Warrenton Planning Commission

TO: Warrenton Planning Commission
FROM: Mark Barnes, Interim City Planner
RE: Site Design Review Application, SDR 20-06, The Scoular Company

Re: Port of Astoria – Scoular Fishmeal Facility – Planning Application Review

FIRE TRUCK TRACKING
 SCALE: 1" = 50'

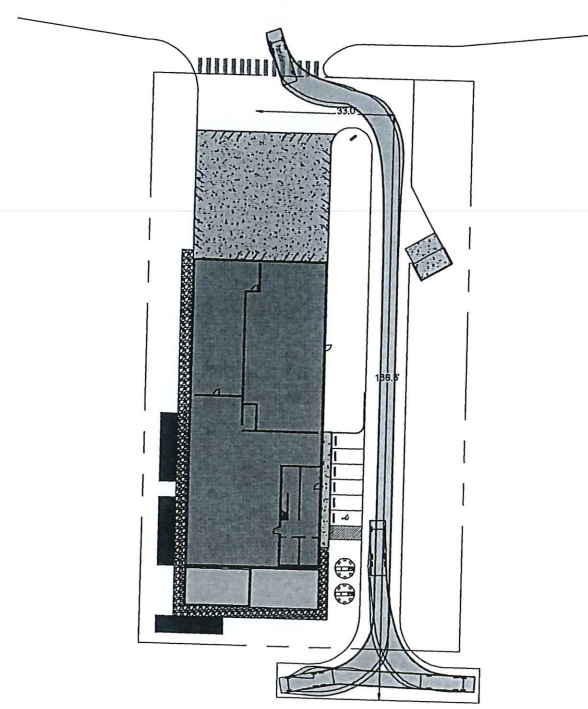
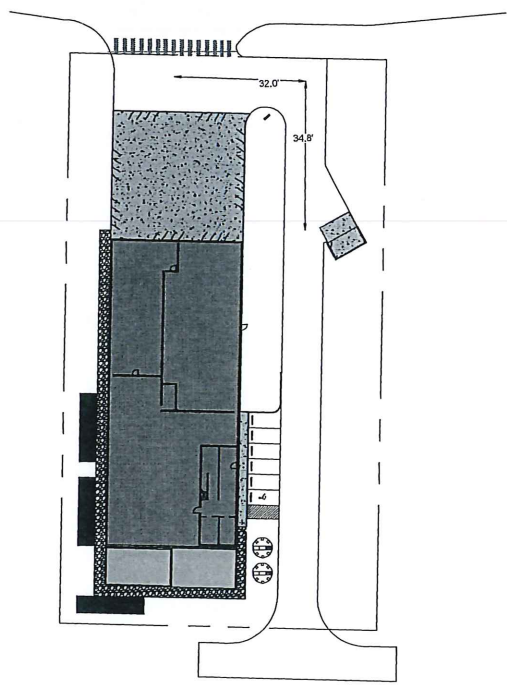
20. Show turning paths of fire truck, garbage truck, busses, and tractor-semitrailer at the intersection Hwy 101 business/Airport Lane.
21. Final stormwater report will include a downstream analysis for all impacted stormwater systems and end at the Youngs Bay or Lewis and Clark River. Analysis shall include pre and post development flows and note any current or future deficiencies. Provide a drawing that clearly shows storm drainage paths and includes existing and proposed infrastructure. Provide one sheet that shows entire stormwater system.
